STAFF ANALYSIS

Case No.: Z-20-1244238 **Agenda #:** D-5

Request: To rezone properties from R-85 (Residential Medium Lot-85) District to RSM (Small Lot Residential Mix) District to construct urban single-family detached townhomes at a density of 4.38 units per acre.

Property Owner: Erskine Park, LLC

ZONING MASTER PLAN

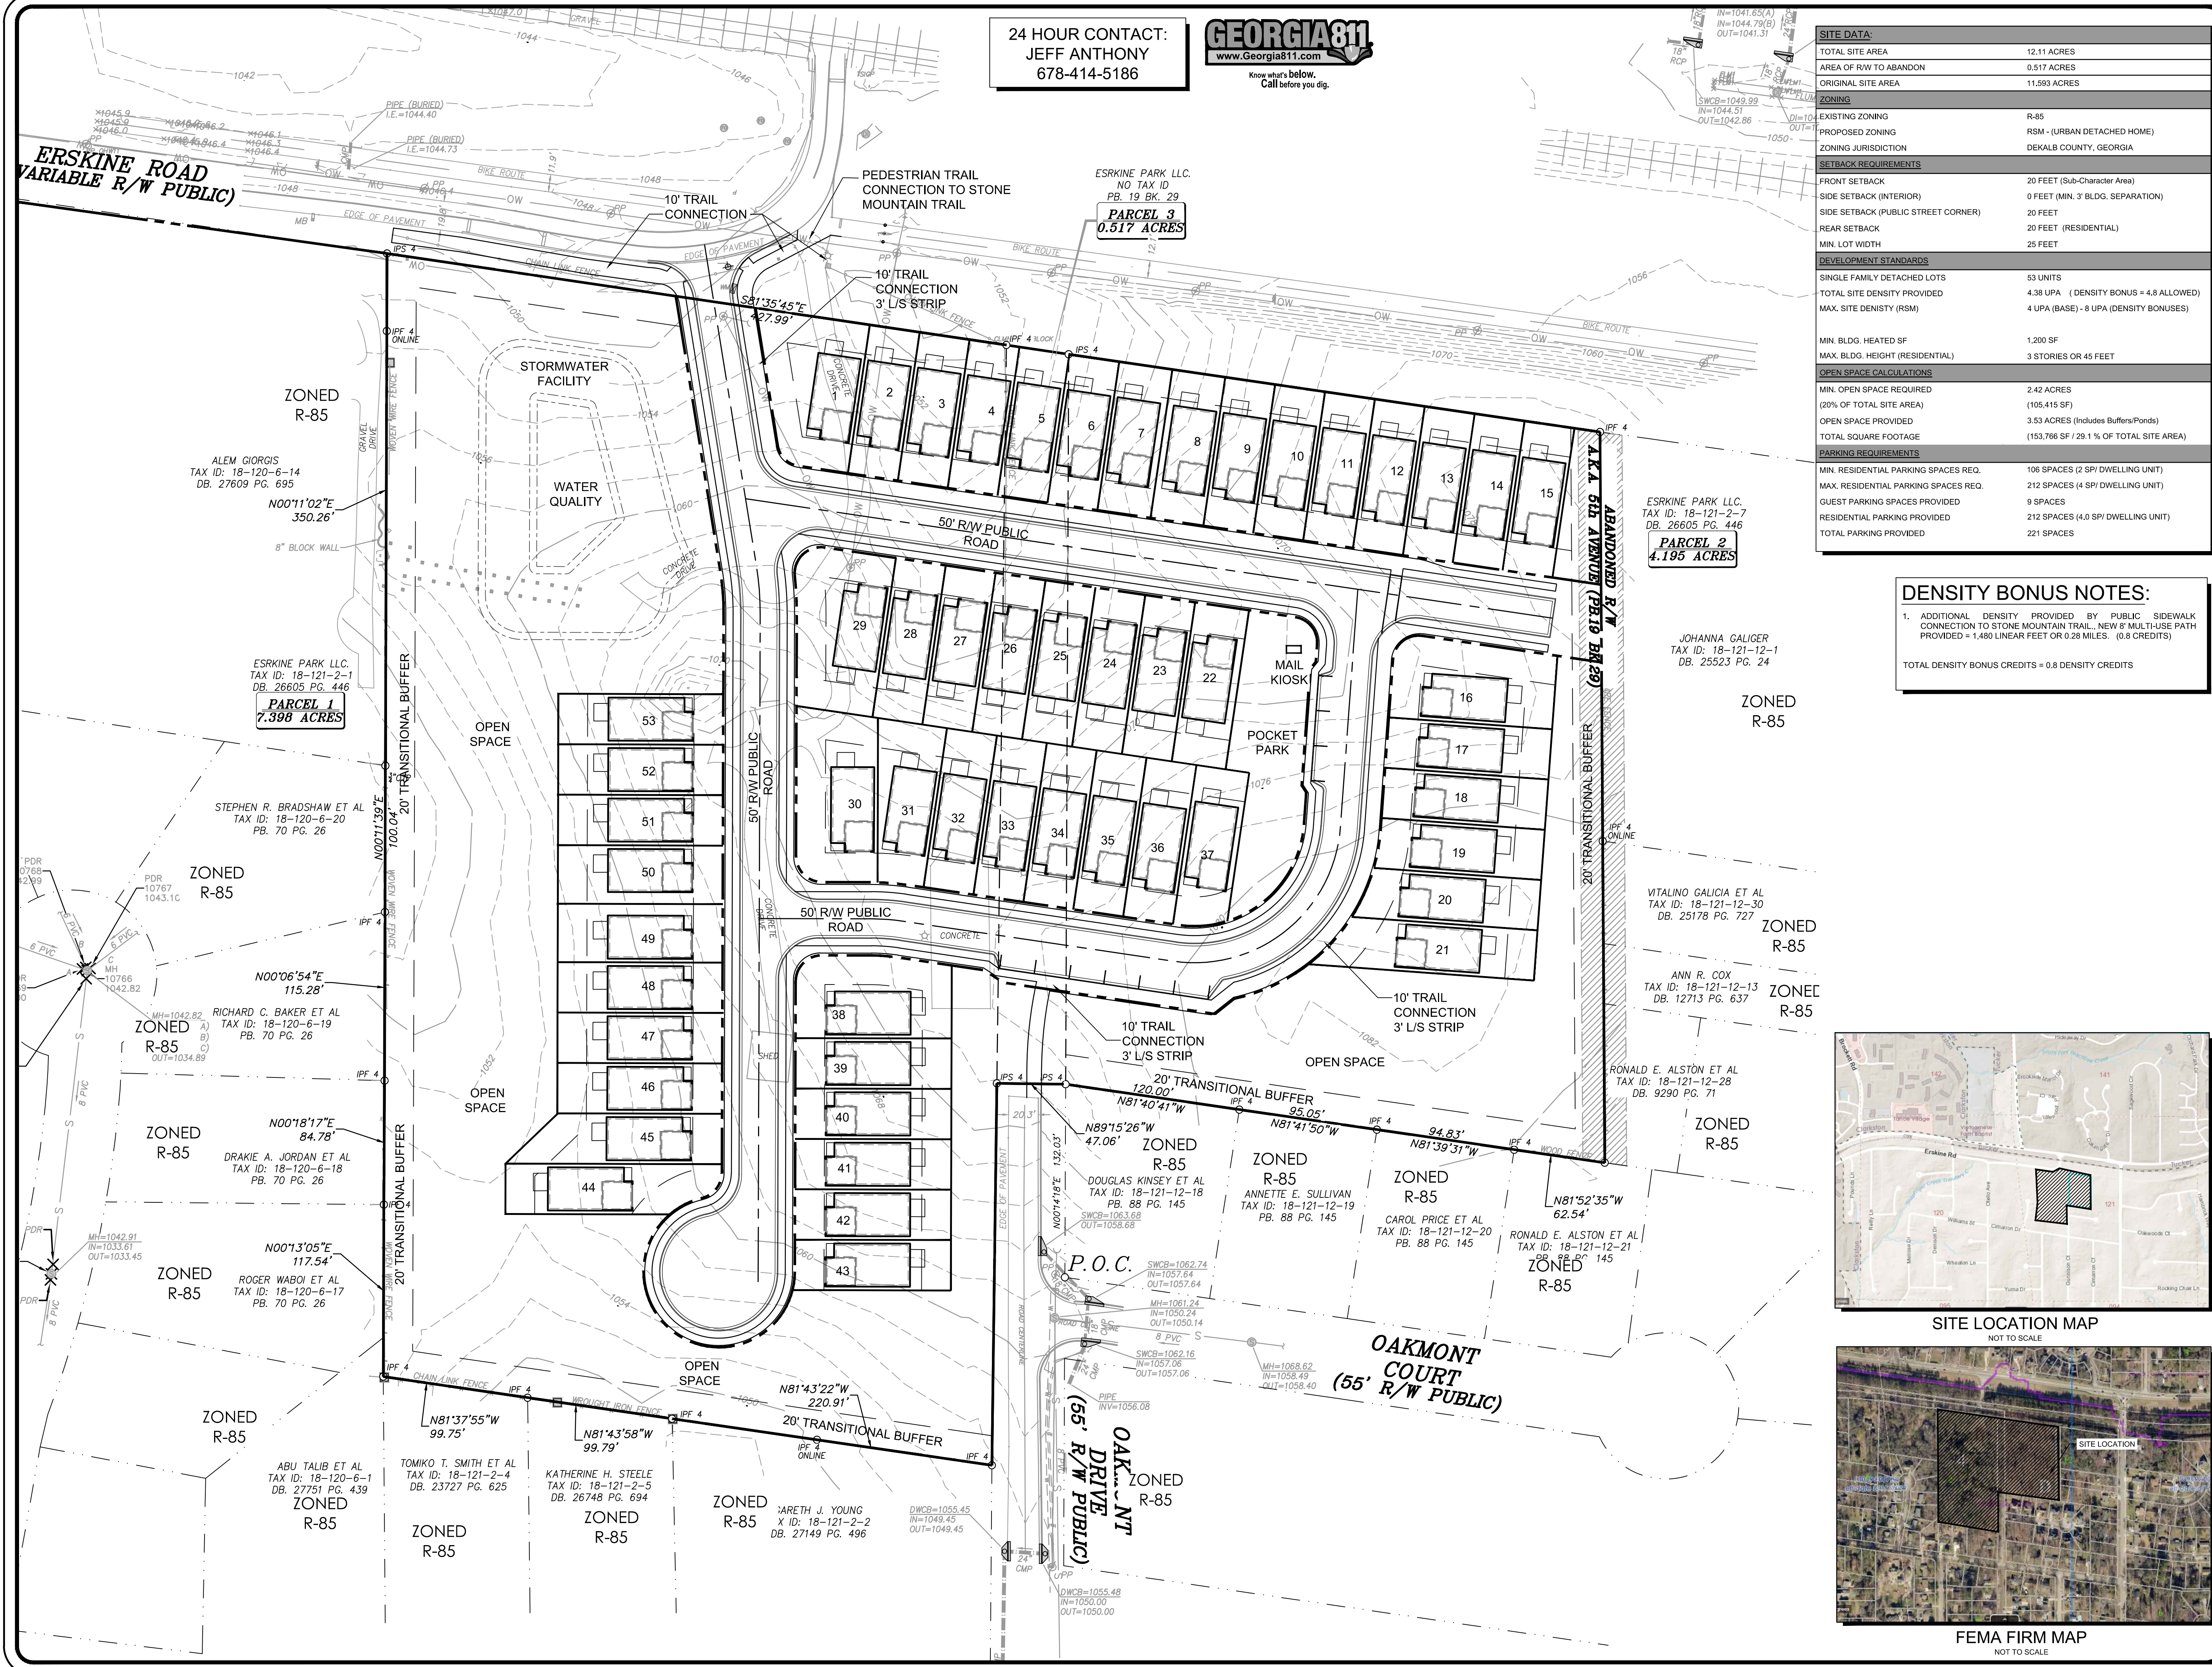
At the November 19, 2020 Board of Commissioners meeting, the applicant's plans proposed urban single-family homes with buildings located (within three feet of each other on small 25-foot wide lots which were not compatible with the traditional, suburban, single-family, detached homes in the surrounding R-85 zoned subdivisions which contain homes located at least ten feet away from each other. The Planning Department recommended "Full Cycle Deferral" to allow sufficient time for the applicant to revise the site plan and rezoning application to consider a more traditional single-family detached site design (with buildings at least ten feet away from each other) that would be more compatible with the surrounding R-85 single-family residential development pattern.

ZONING MASTER PLAN

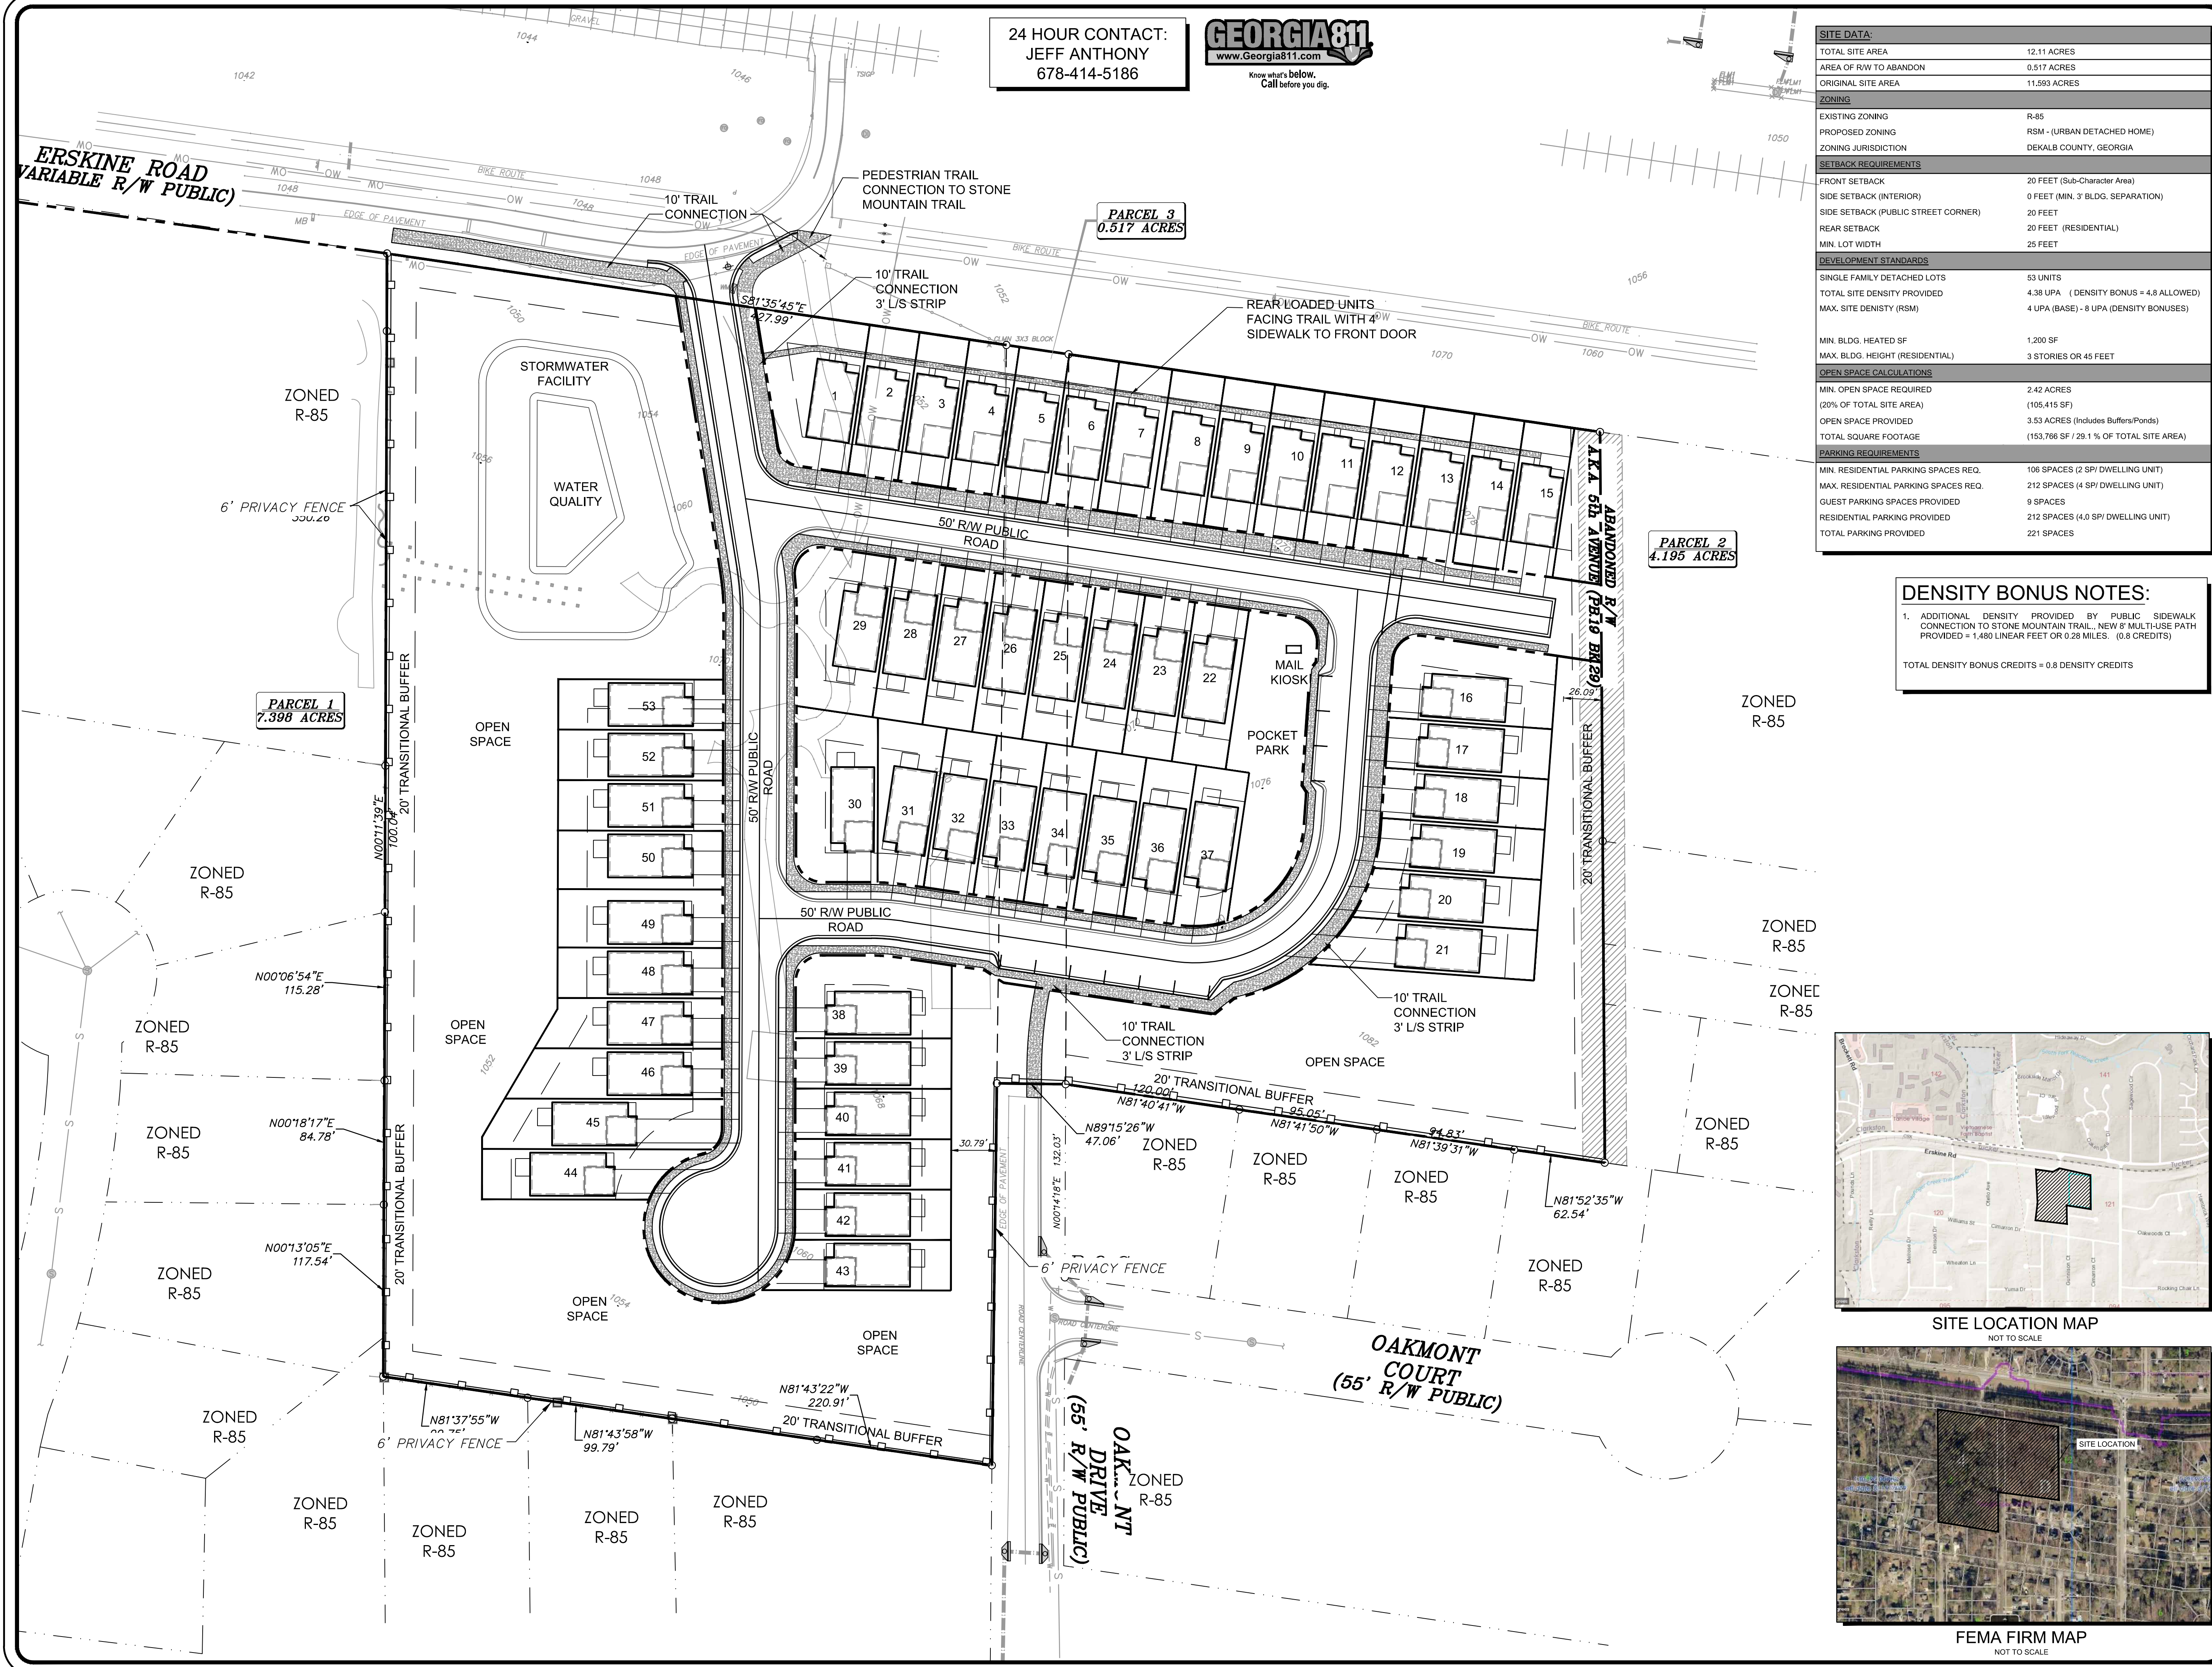
Since the November 19th Board of Commissioner meeting, the applicant has submitted revised site plans to decrease the number of units from 63 (5.2 units per acre) to 53 (4.38 units per acre) urban detached townhomes and increased the amount of open space from 25% to 29% (only 20% required). However, the proposed urban detached "townhomes" are still located close together (within five feet of each other); on 25-foot wide, 1,350 square foot lots; and are not compatible with the traditional suburban detached homes in the adjacent and surrounding R-85 zoned subdivisions. Those homes are at least ten feet from each other; on lots with minimum sizes of at least 12,000 square feet; and minimum lot widths of 85 feet (Sec. 7.3.5.B). It does not appear that the proposed rezoning request is consistent with the policies and strategies of the Suburban Character Area to protect stable neighborhoods from incompatible development that could alter established single-family residential development patterns (Suburban Policy #1). While RSM zoning is located in the general area (approximately two tenths of a mile to the west (Country Address Subdivision) and three tenths of a mile to the east (Joshua Crossing Subdivision and others), those RSM zoned subdivisions contain traditional suburban single-family homes at least ten feet away from each other. Permitting the proposed request at this location would allow the encroachment of urban, single-family homes in an area intended to be developed with traditional, suburban, single-family, detached homes.

The Transportation Department has indicated that the applicant needs to verify intersection sight distance for Erskine Road for existing vehicles and stopping sight distance for cars waiting to turn left into the development (see attached Transportation comments). However, no such information has yet been submitted to the Planning Department. Therefore, it cannot be determined if the proposed request will result in a burdensome use of existing streets and transportation facilities. (Sec. 7.3.5.G) Upon consideration of the above-mentioned concerns, it is the recommendation of the Planning and Sustainability Department that the rezoning application be "denied".

Notwithstanding Staff's recommendation, since the original plans were submitted it appears that there may be more significant community support for the project due to the extraordinary amount of open space (29% provided and only 20% required) and tree preservation being provided on the revised plans between the proposed lots and the adjacent subdivisions. The applicant has held numerous discussions with community stakeholders. Should the rezoning request and revised plans be approved, Staff offers the following recommended conditions for consideration:

1. Verify intersection sight distance for Erskine Road for existing vehicles and stopping sight distance for cars waiting to turn left into the project and obtain County Transportation Department approval prior to the issuance of any land disturbance permits.

2. Limit the maximum number of urban detached townhomes to 53.
3. General compliance with the location of proposed open space on plans dated 12/14/2020 shall be required along with 29% minimum amount of open space.

14. Units 1 – 15 and 16 -21 which are located closest to the Stone Mountain Trail will be rear-entry units as shown on Site Plan dated 12/14/20 as prepared by Planners and Engineers Collaborative.
